Technical Service Information

FORD AODE/4R70W FALLS OUT OF 4TH INTO NEUTRAL, REPEAT INTERMEDIATE ROLLER CLUTCH FAILURE REPEAT OVERDRIVE BAND FAILURE FORWARD DRUM AND /OR STATOR FAILURE

COMPLAINT: Some 1992-1993 model year Crown Victoria and Grand Marquis vehicles may exhibit any or all of the repeat failures listed above. Usually the vehicle comes in with 20 to 40 thousand original miles, and after overhaul, you experience a repeat failure in 1500 to 2500 miles.

Figure 1

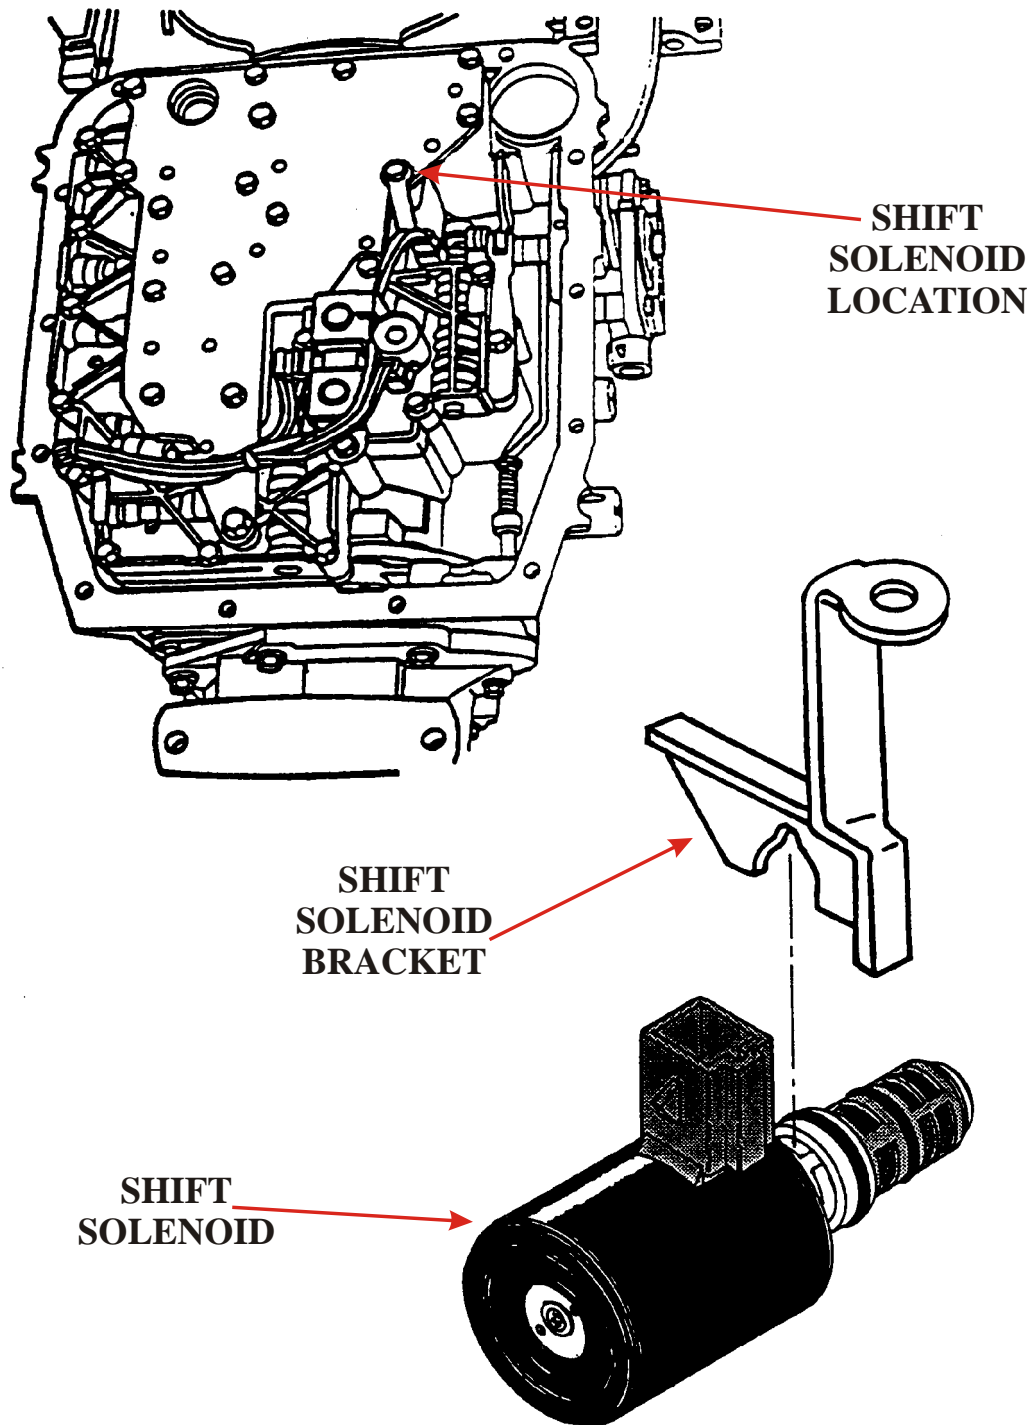
CORRECTION: **NUMBER (1)** - There is now a New Design EPC Solenoid available under OEM part number F3AZ-7G383-A. ALWAYS replace the Electronic Pressure Control (EPC) Solenoid with the new design, and ensure that retaining bracket is secured in the proper position. The retaining bracket must be installed with the "Fork" of the bracket over the body of the EPC solenoid, and the bracket secured with valve body bolt in the location shown in Figure 1. The EPC Solenoid may have to be repositioned slightly for "Fork" of the bracket to engage in the proper position. Refer to Figure 1. Manual shaft lever must be removed from the case to replace the EPC Solenoid.

Figure 2

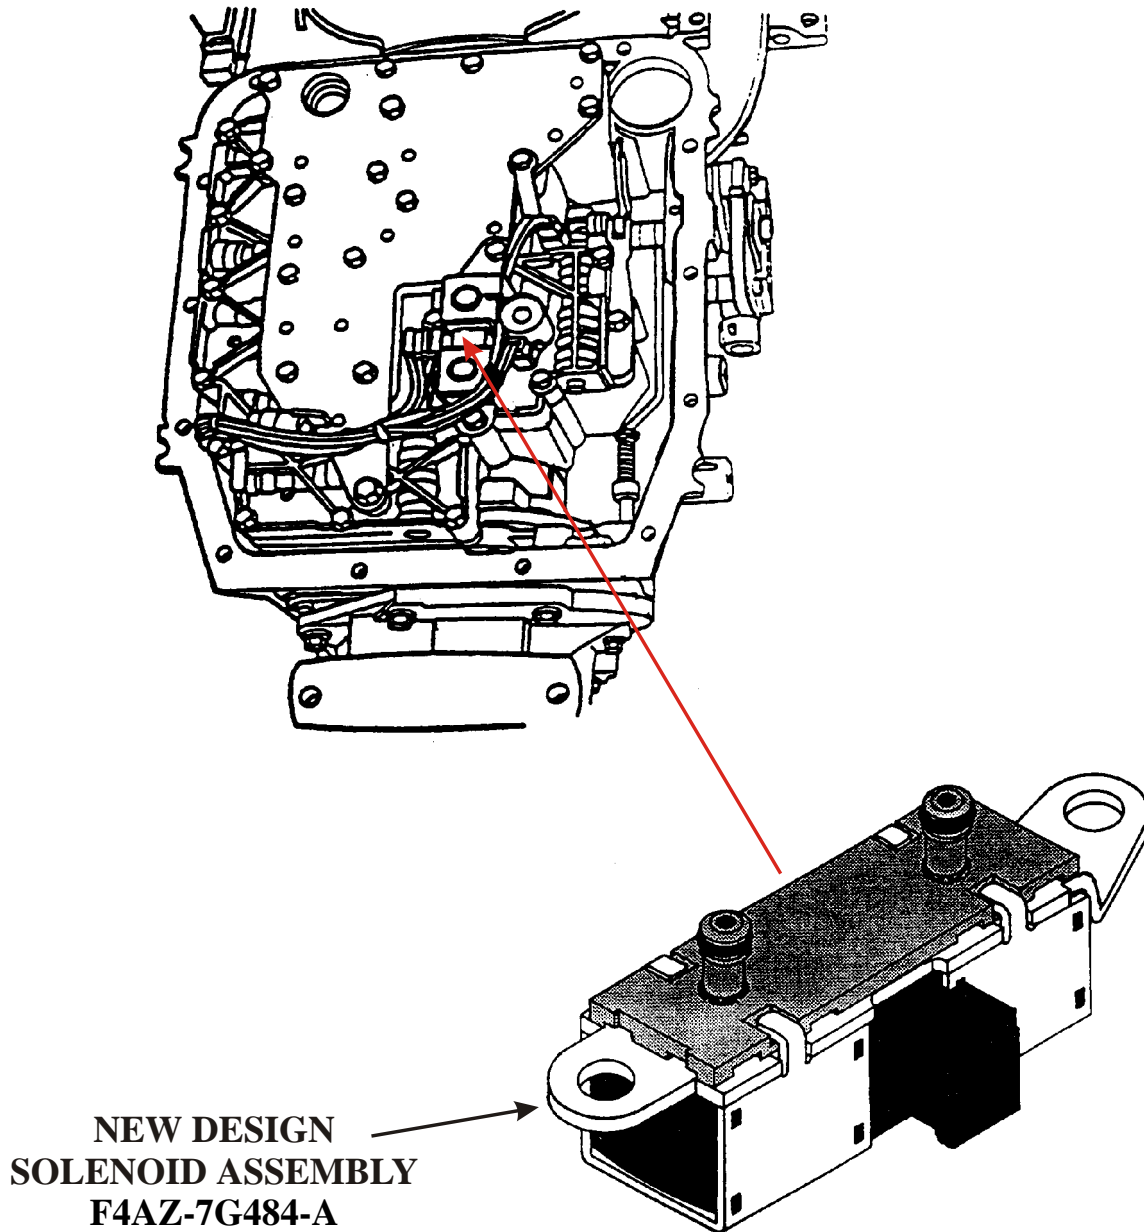
NUMBER (2) - There is now a New Design Shift Solenoid Assembly available under OEM part number F4AZ-7G484-A. ALWAYS replace the Shift Solenoid Assembly with the new design, as shown in Figure 2.

Figure 3

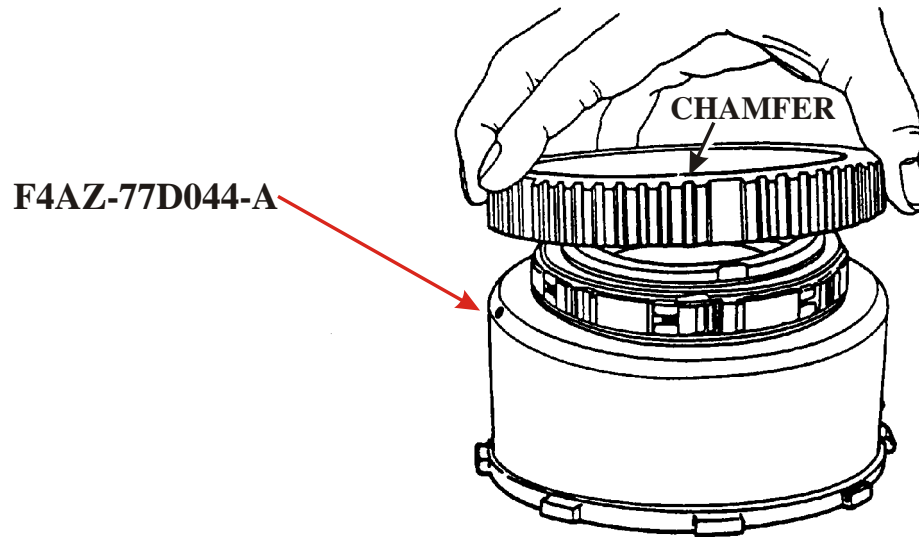
NUMBER (3) - There is now available a New Design Reverse Drum and Intermediate Roller Clutch Assembly with the following revisions;

1. Improved spring design for the rollers.
2. Revised cam to improve oil distribution.
3. Grooved outer race to reduce vibration.
4. Elimination of the gap between the outer race and reverse drum for improved roller clutch cage support.
5. Reverse drum assembly now balanced in production.
6. Machining tolerances reduced on reverse drum.

ALWAYS replace the Reverse Drum and Intermediate Roller Clutch Asm, with the new design, OEM part number F4AZ-7D044-A, as shown in Figure 3. ATSG recommends installing the spiral snap ring from a TBM 125 or 440-T4 final drive, OEM part number 11501326, in place of the original snap ring for the intermediate roller clutch.

Figure 4

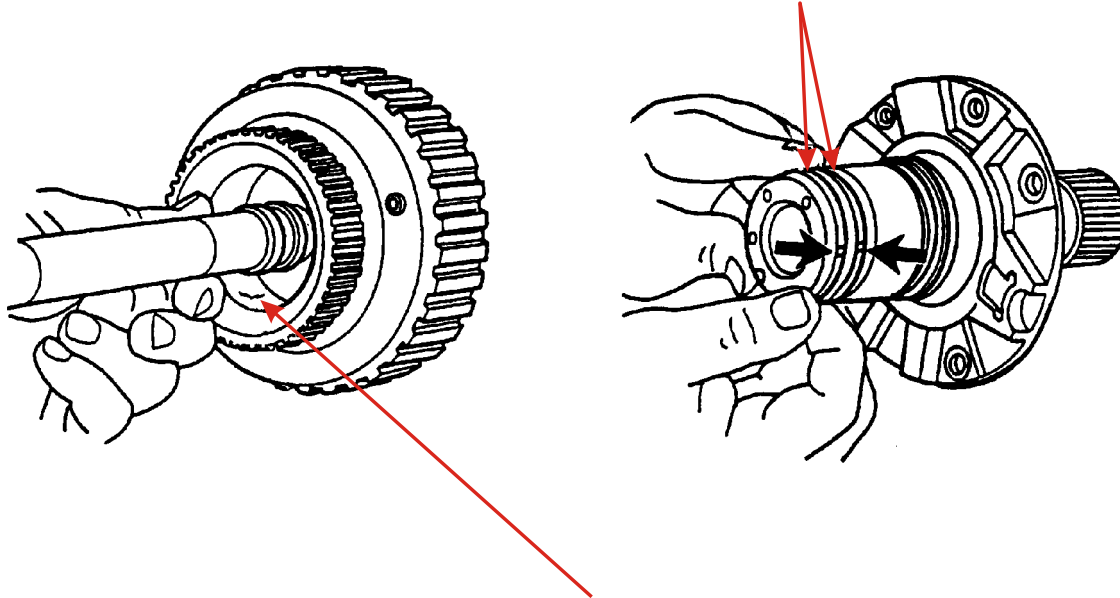
NUMBER (4) - There are now New Design Forward Clutch Sealing Rings, available under OEM part number F4AZ-7D019-A, that are plated. ALWAYS replace the Forward Clutch Sealing Rings with the new design, as shown in Figure 4.

Figure 5

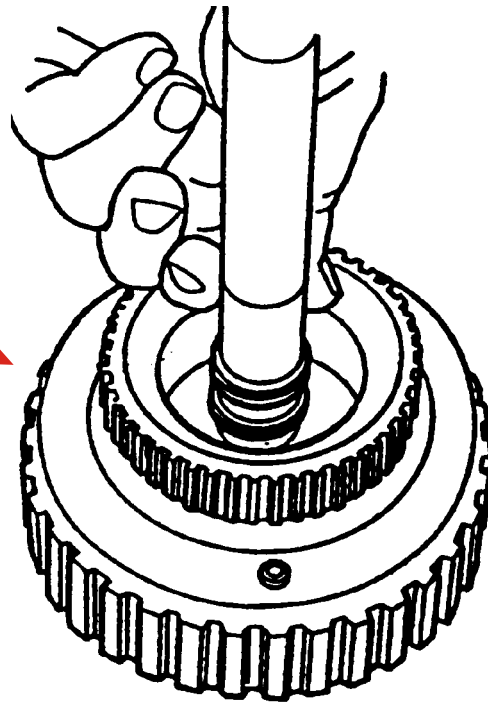
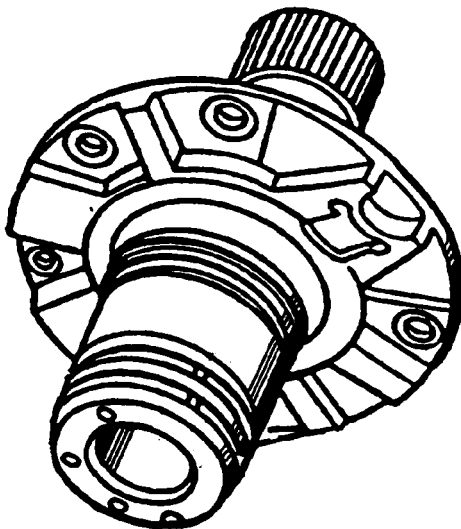
NUMBER (5) - Some early models were built with a Forward Clutch Drum and/or Pump Support (Stator), with a "Rough" micro-finish where the sealing rings ride in the Pump Support. Simply replacing these parts with the updated OEM parts will eliminate these concerns. The New Design Forward Clutch Drum is available under OEM part number F3LY-7F207-A, and the New Design Pump Support available under OEM part number F4AZ-7A108-A (See Figure 5).

Figure 6

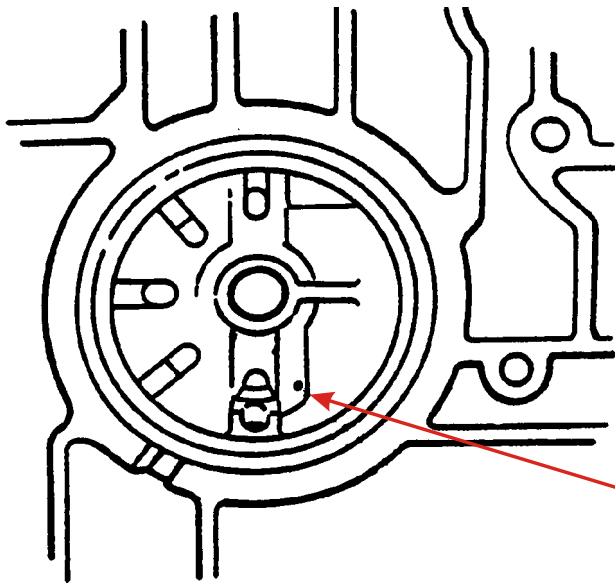
NUMBER (6) - Inspect the .020" bleed orifice located in the overdrive servo bore, in the location shown in Figure 6. This bleed orifice is difficult to see, but MUST be there, and MUST BE OPEN, for the over-drive band to apply properly. ALWAYS inspect this bleed orifice to ensure that it is free of all contamination, and open to the inside of the case (See Figure 6).

THIS .020" BLEED ORIFICE MUST BE FREE FROM CONTAMINATION

Figure 7

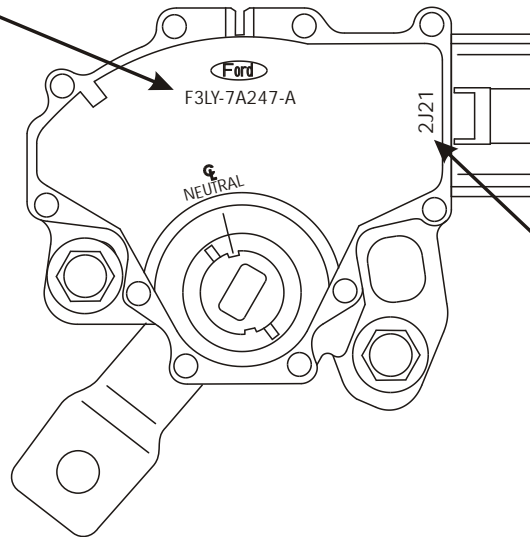
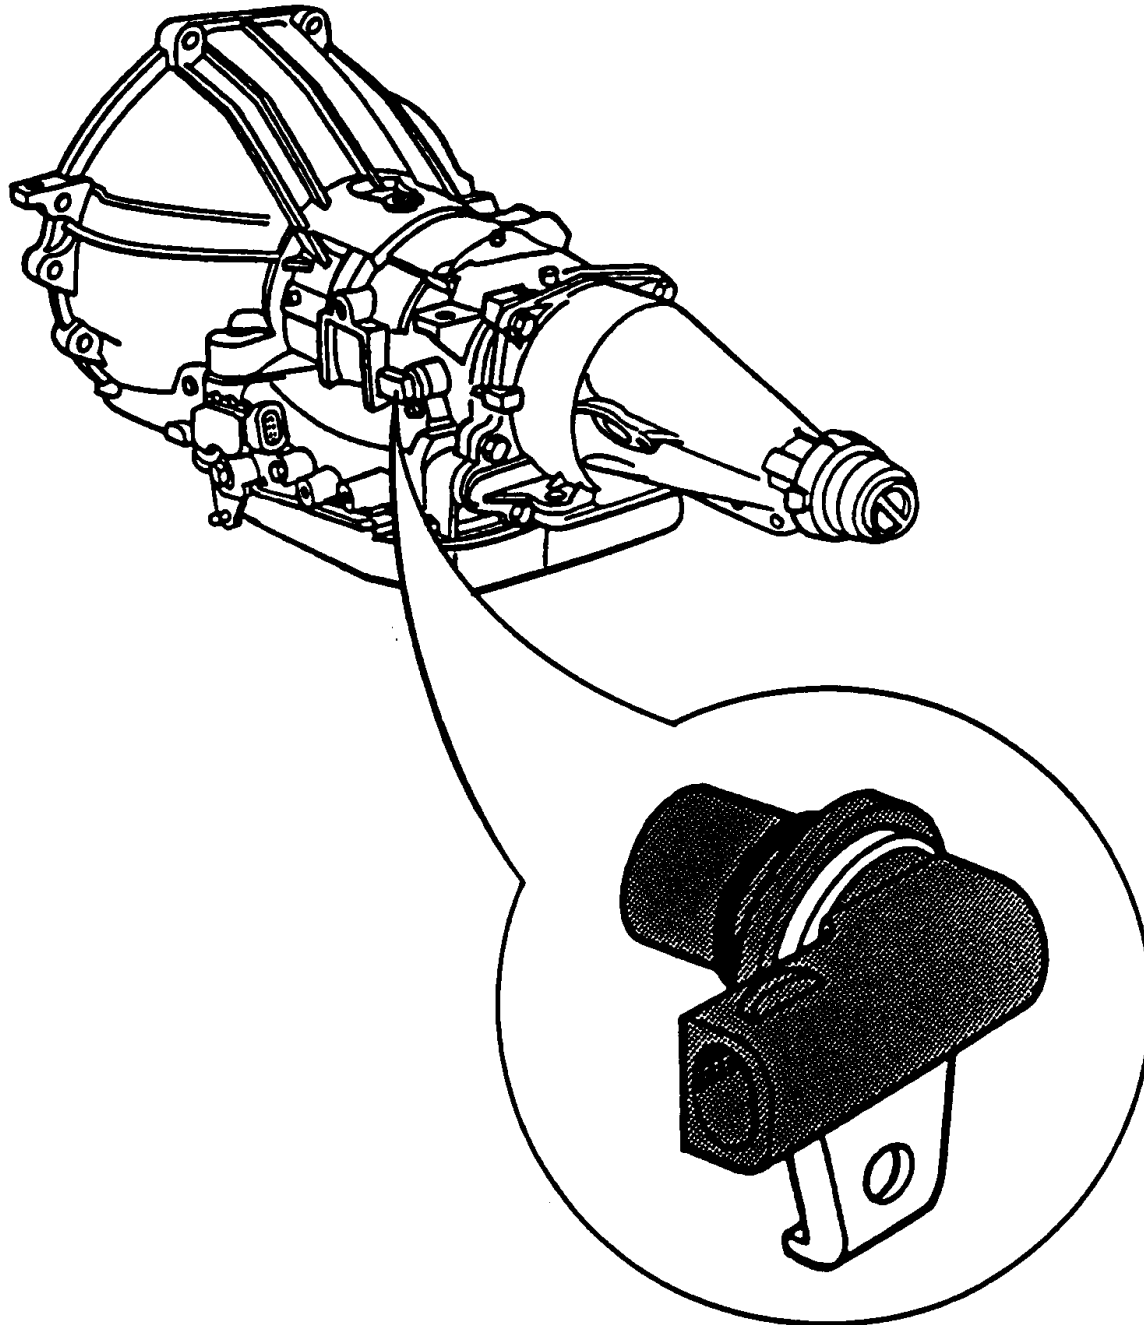
NUMBER (7) - The Manual Lever Position Switch is very susceptible to contamination from road water, snow, mud, and interference with the insulation material on the floor pan above it. Simply cut away enough of the insulation to provide sufficient clearance between the top of the MLPS and the floor pan. Inspect for bent pins in the connector. ALWAYS replace the MLPS with a revised service level MLPS that is more resistant to internal contamination, with the following part numbers;

DO NOT USE MLPS WITH DATE CODES OF 2521 THRU 2LO6.

The date code is stamped on the outer cover of the Manual Lever Position Switch, as shown in Figure 7.

Figure 9

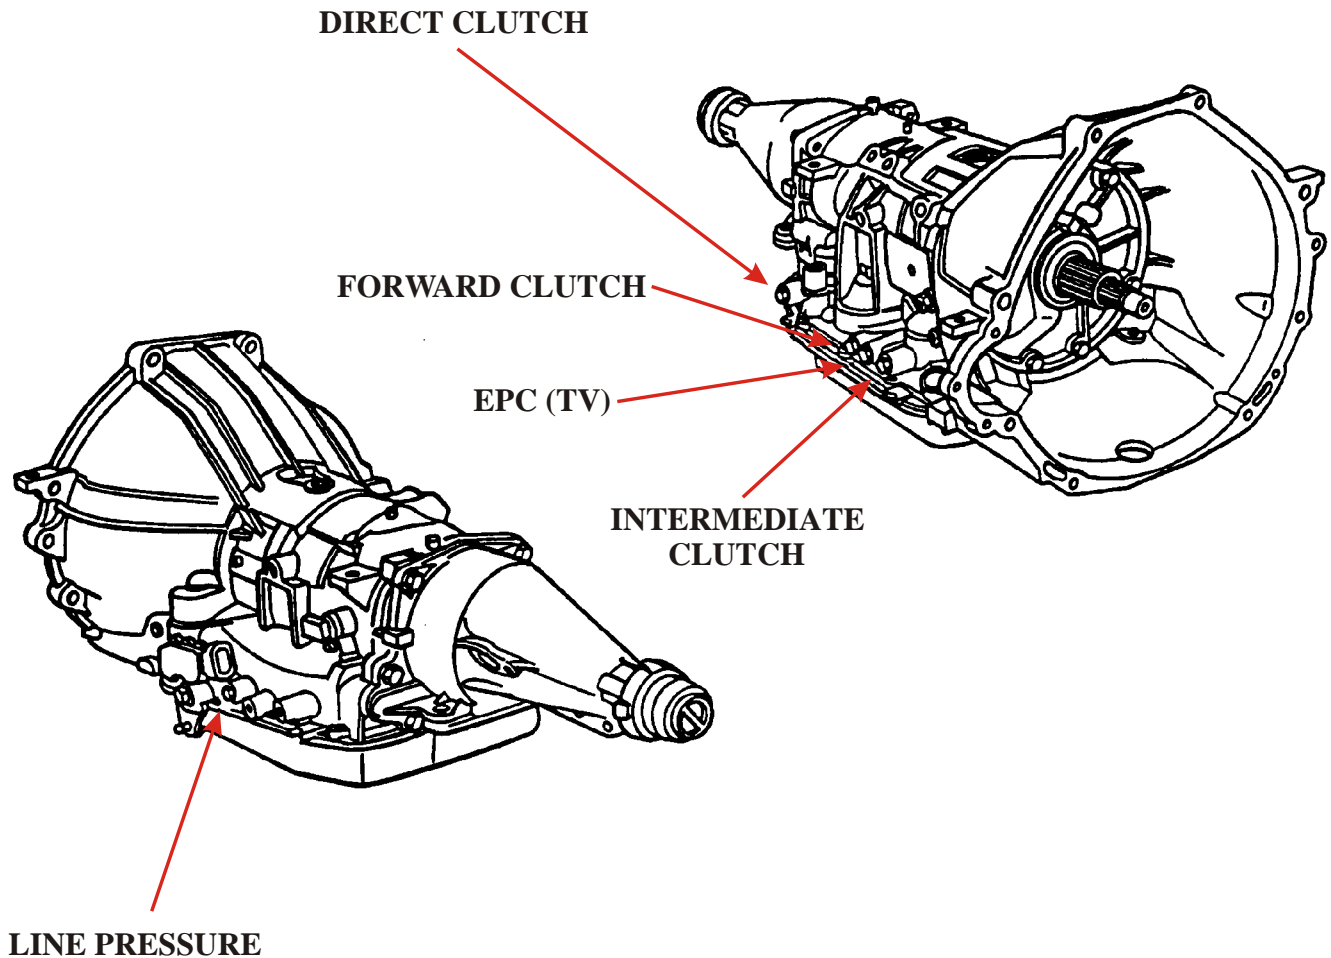
NUMBER (13) - ALWAYS check and verify all line pressures, and that you have line pressure rise with throttle opening, BEFORE the vehicle is delivered back to the customer. Use the chart in Figure 9 for line pressure specifications, and the locations of the various pressure taps.
